**ADDENDUM NO. 2****Date of Issue: 1 February 2022**

Project: Renovations to Building 1000 Surgical Technology Lab  
Client: Horry-Georgetown Technical College  
State Project No.: H59-N085-PG  
DA Project No.: 21-106  
Prepared by: Doyle Architecture, LLC  
315 Main Street, Suite 2B  
Conway, South Carolina, 29526

SHEET:  
**AD-100**

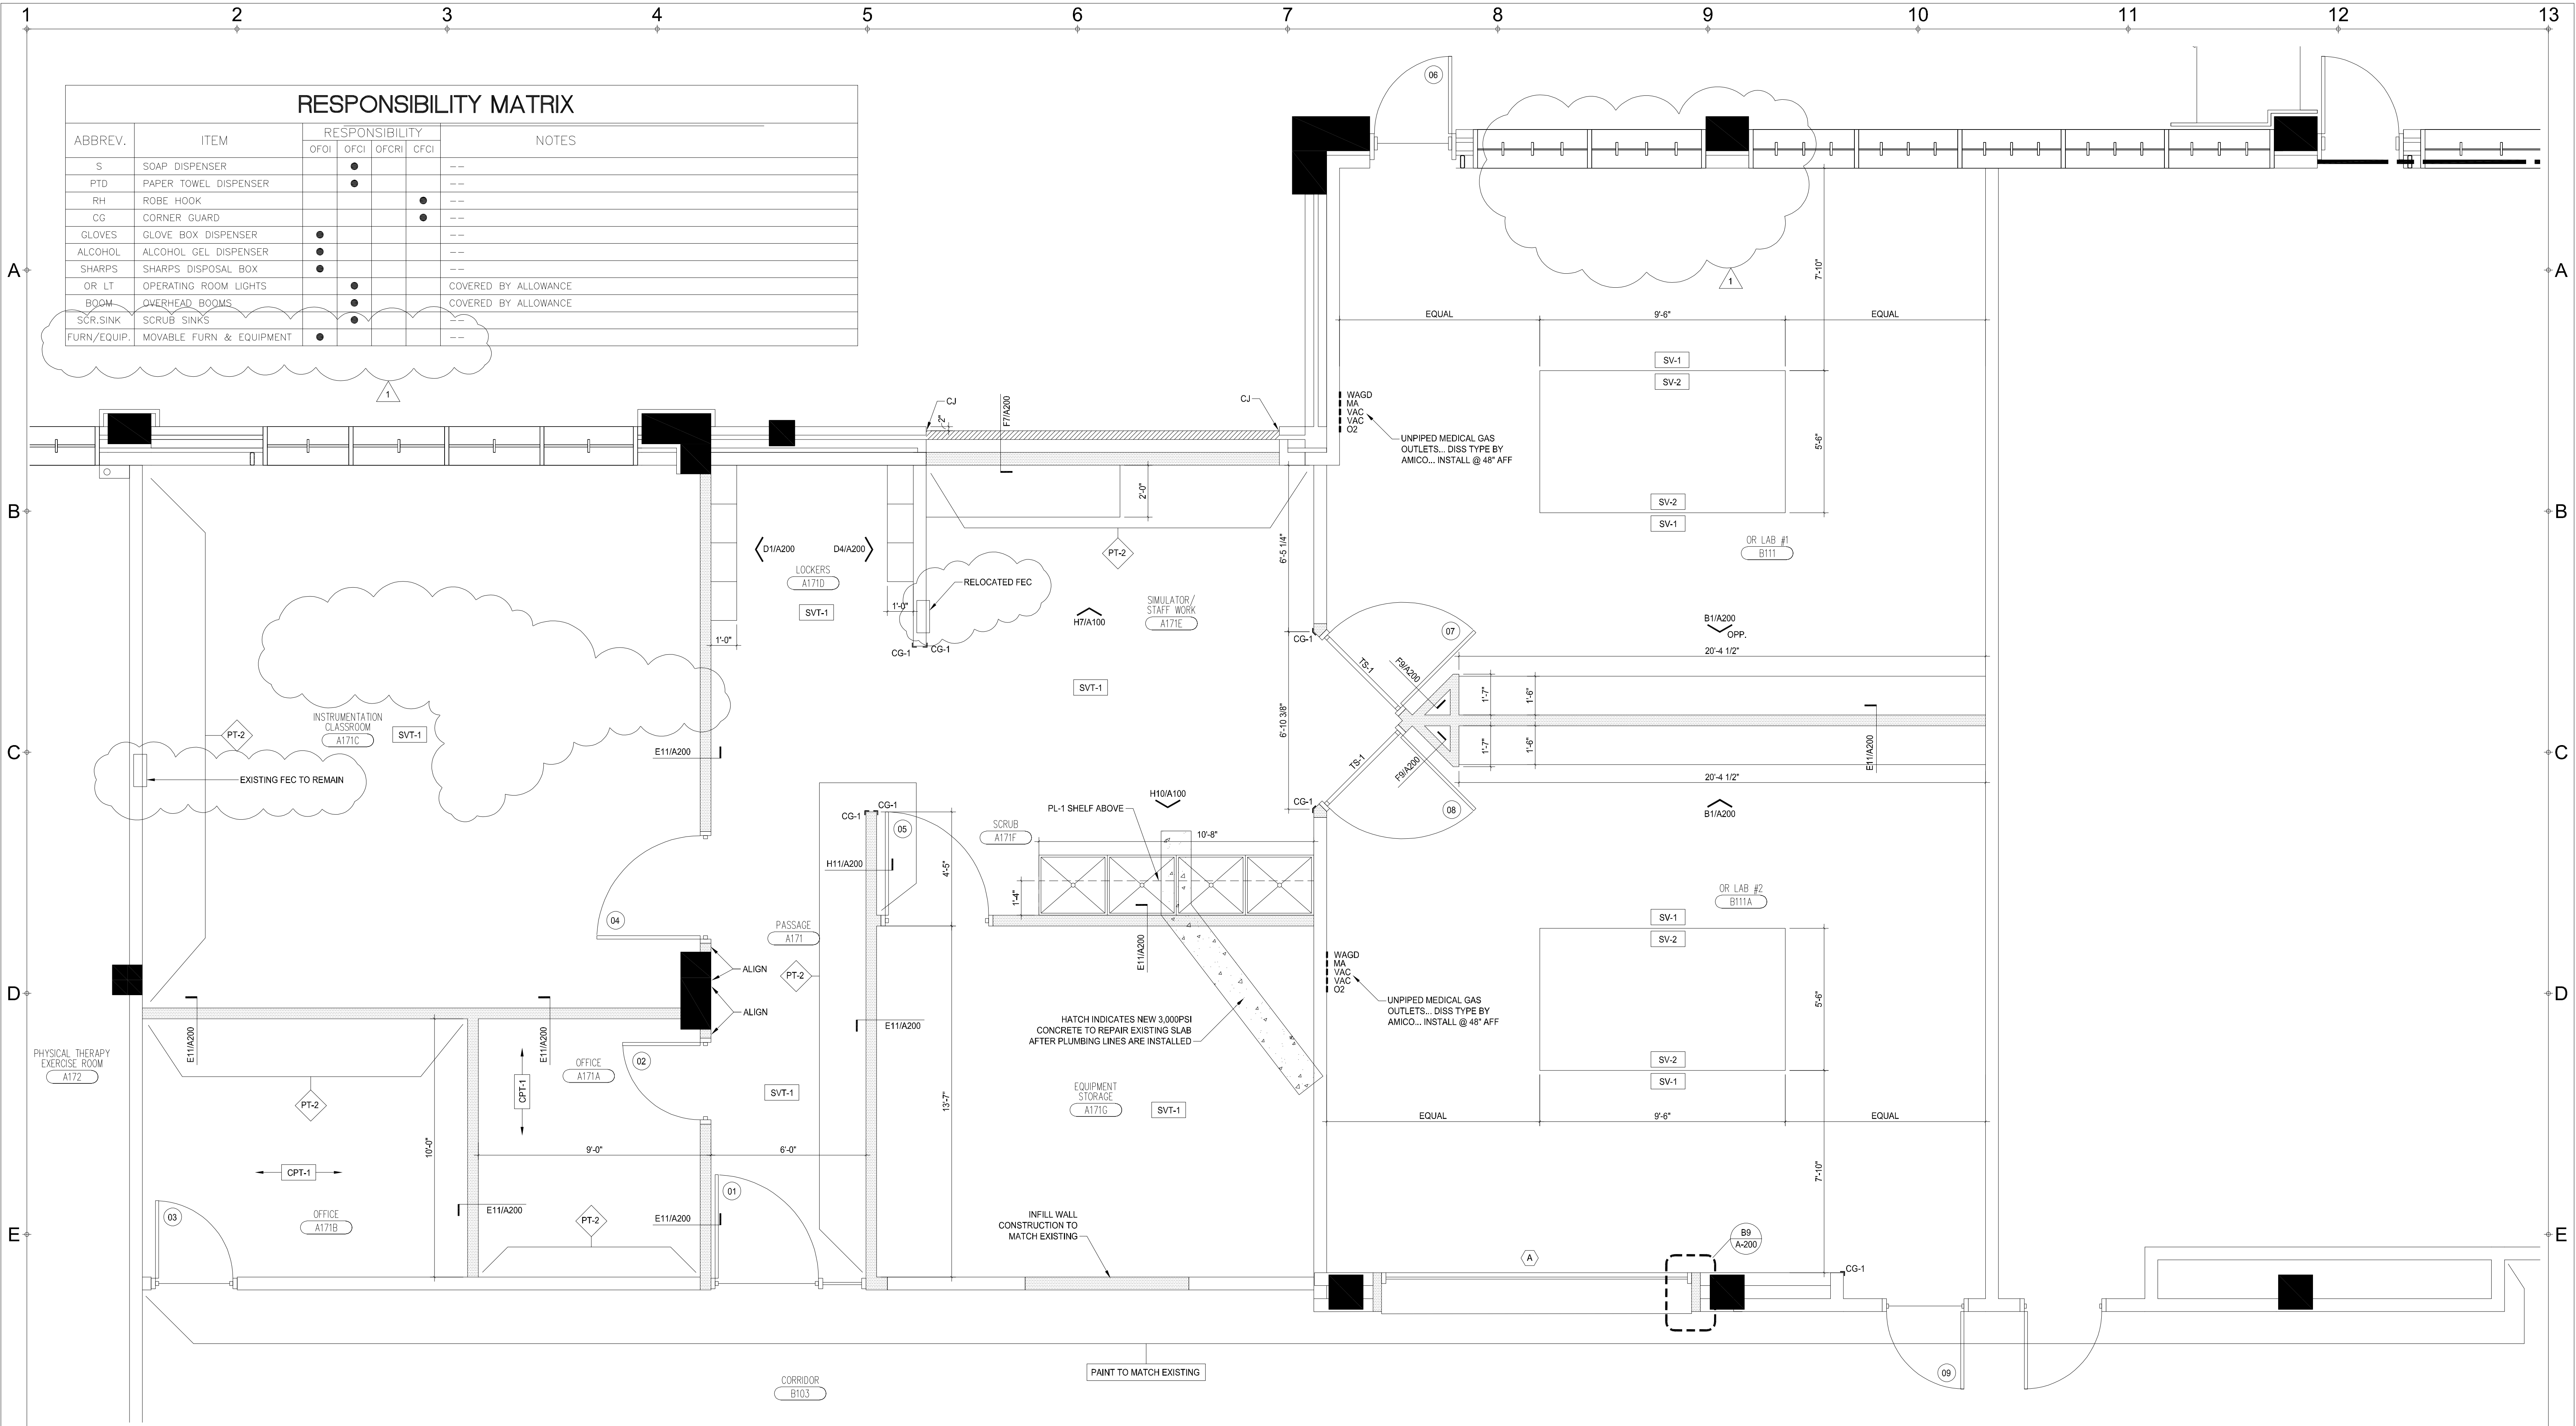
5. Sheet AD-100: Demolition Key Notes
  - A. **DELETE** Keynote 21 as shown on the revised Sheet AD-100 included with this Addendum.

- A. **ADD** Keynote 22 to read, “Existing FEC to remain” as shown on the revised Sheet AD-100 included with this Addendum.
  - B. **ADD** Keynote 23 to read, “Existing FEC to be removed and relocated. See New Floor Plan” as shown on the revised Sheet AD-100 included with this Addendum.

6. Sheet AD-100: Demolition Floor Plan
- A. **ADD** Keynote 22 to indicate existing FEC to remain as shown on the revised Sheet AD-100 included with this Addendum.

- B. **ADD** Keynote 23 to indicate the existing FEC that is to be removed and relocated as shown on the revised Sheet AD-100 issued with this Addendum.

- C. **ADD** General Note 1 that reads, “The Contractor shall provide HEPA filters at all existing return air and exhaust ductwork to prevent dust from entering the existing HVAC system, and shall maintain negative pressure throughout the construction zone relative to the surrounding areas” as shown on the revised Sheet AD-100 included with this Addendum.

- D. **DELETE** area of existing concrete slab to be removed near Scrub A171C as shown on the revised Sheet AD-100 included with this Addendum.
7. Sheet A-100: Responsibility Matrix

GENERAL NOTE 1: THE CONTRACTOR SHALL PROVIDE HEPA FILTERS AT ALL EXISTING RETURN AIR AND EXHAUST DUCTWORK TO PREVENT DUST FROM ENTERING THE EXISTING HVAC SYSTEM, AND SHALL MAINTAIN NEGATIVE PRESSURE THROUGHOUT THE CONSTRUCTION ZONE RELATIVE TO THE SURROUNDING AREAS.

- 21 NOT USED.
- 22 EXISTING FEC TO REMAIN.
- 23 EXISTING FEC TO BE REMOVED AND RELOCATED. SEE NEW FLOOR PLAN.

**F1 NEW FLOOR PLAN**  
 SCALE: 3/8" = 1'-0"

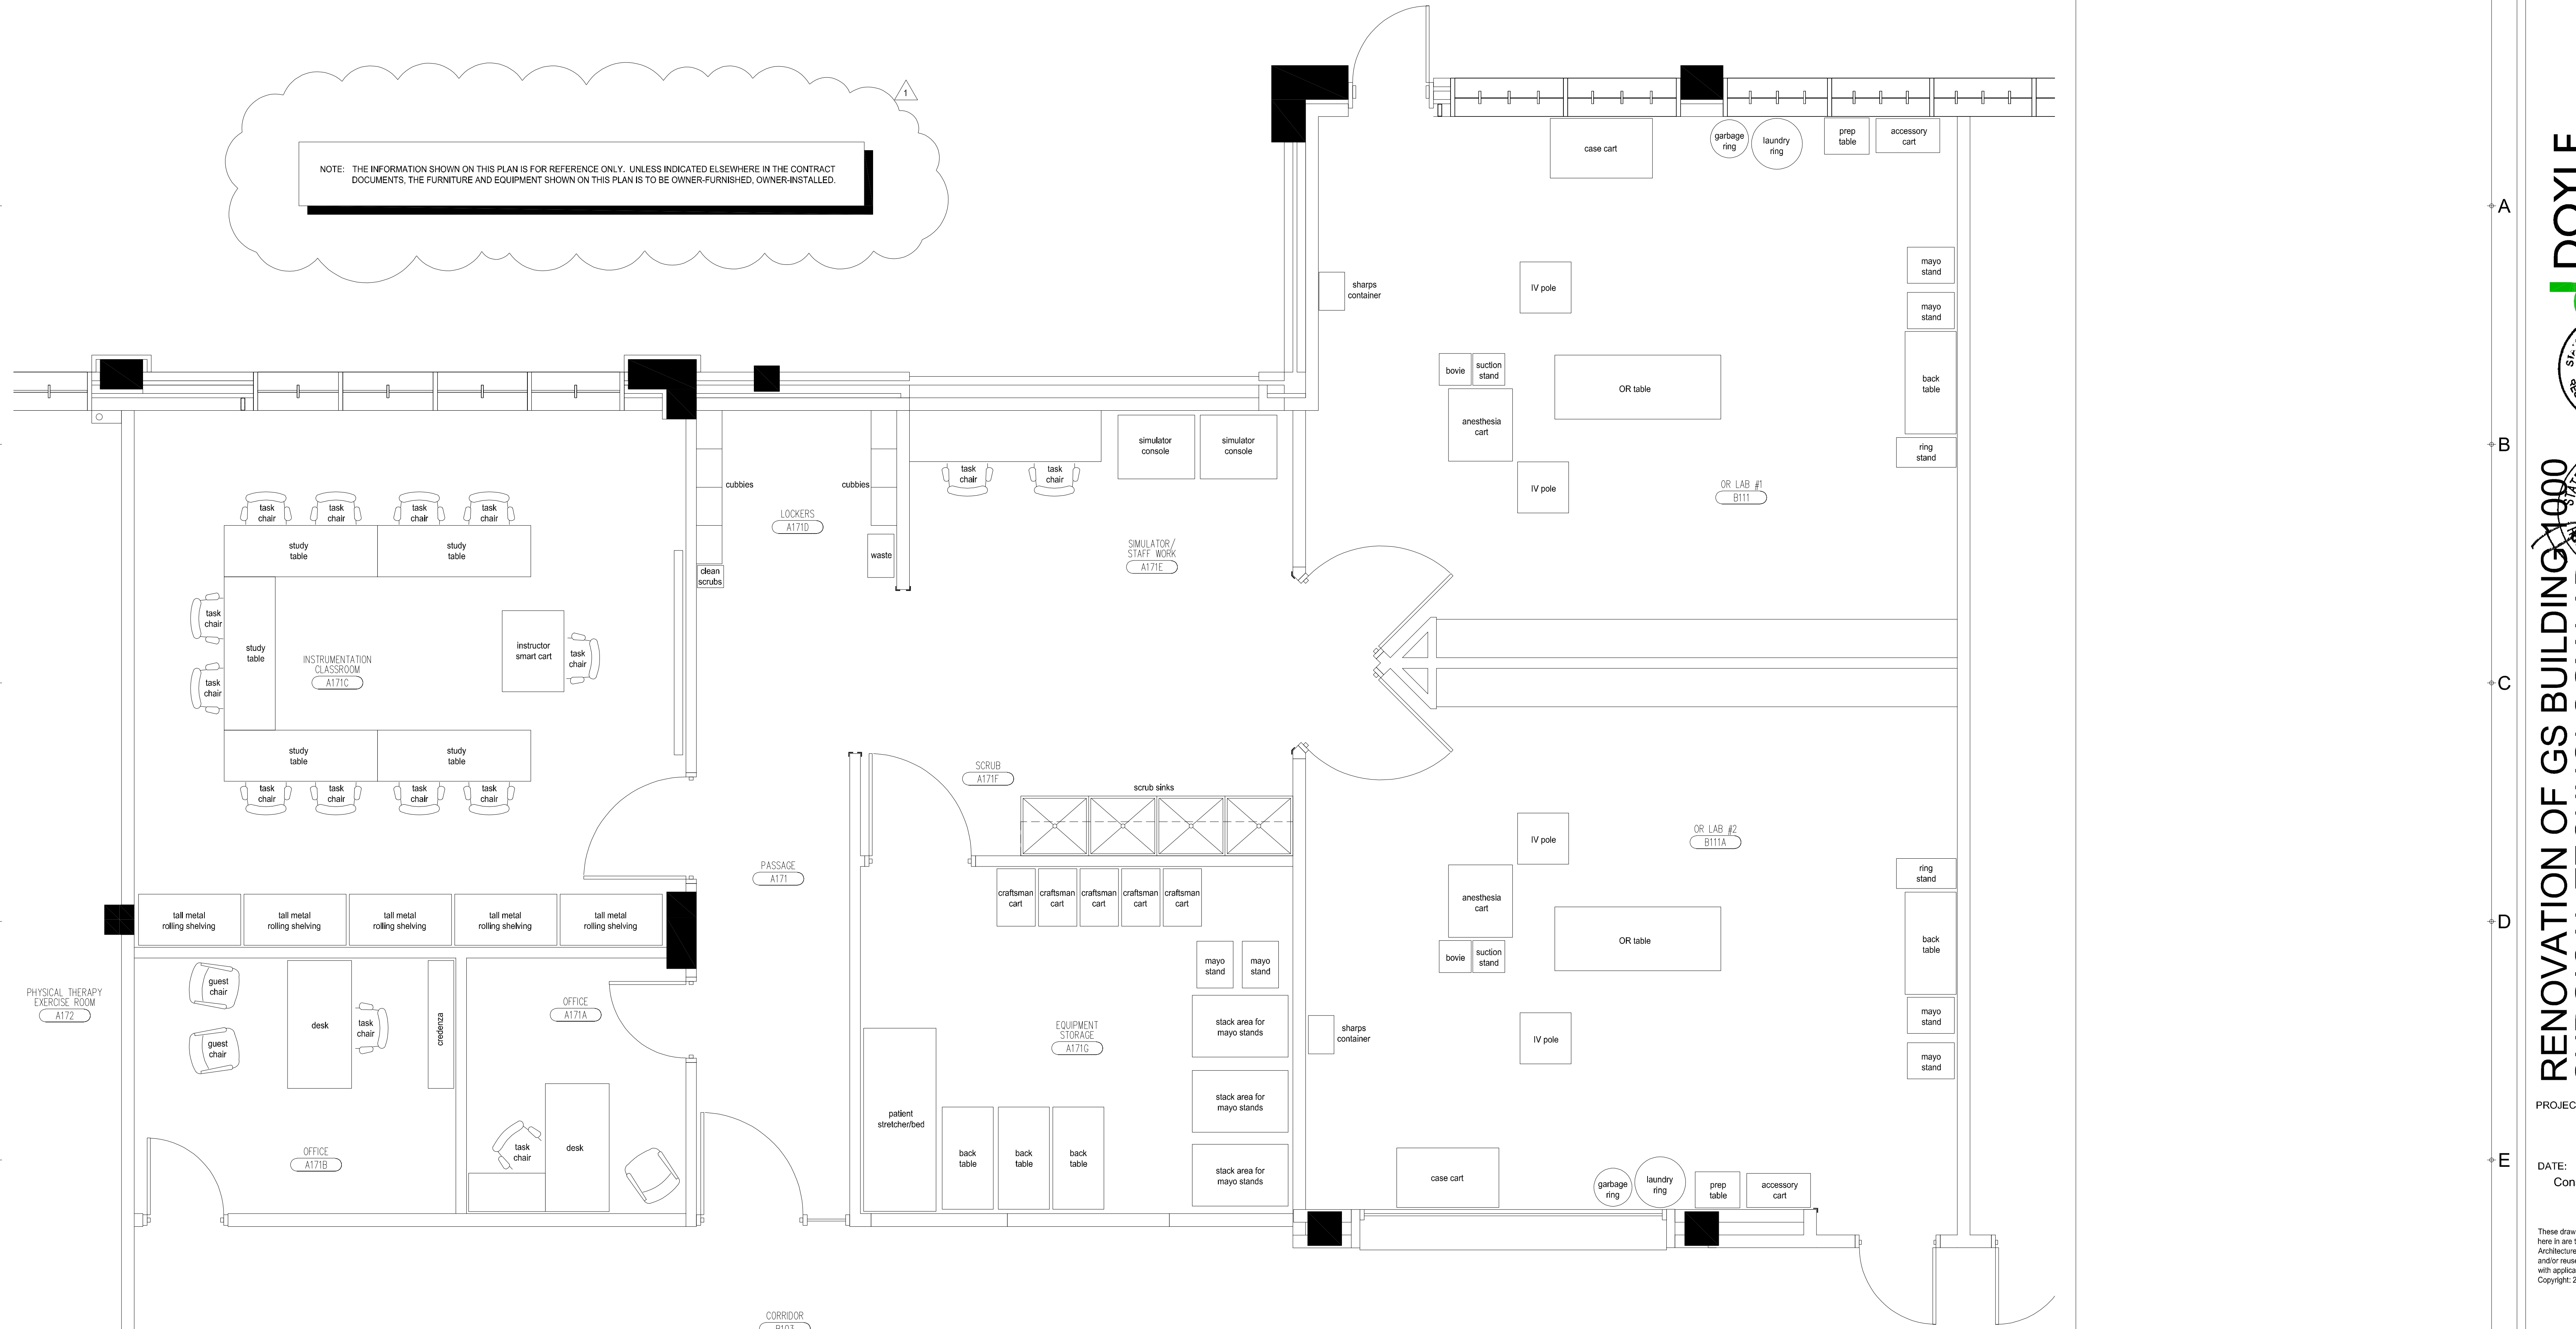
- A. **ADD** a line item indicating Movable Furniture and Equipment as shown on the revised Sheet A-100 included with this Addendum.
8. Sheet A-100: New Floor Plan

- A. **DELETE** the note referring to plastic film in OR Lab #1 as shown on the revised Sheet A-100 included with this Addendum.
  - B. **ADD** the relocated FEC as shown on the revised Sheet A-100 issued with this Addendum.

- C. **ADD** the FEC that is existing to remain as shown on the revised Sheet A-100 issued with this Addendum.
  - D. **DELETE** the area of new concrete slab infill in Instrumentation Classroom A171C as shown on the revised Sheet A-100 issued with this Addendum.
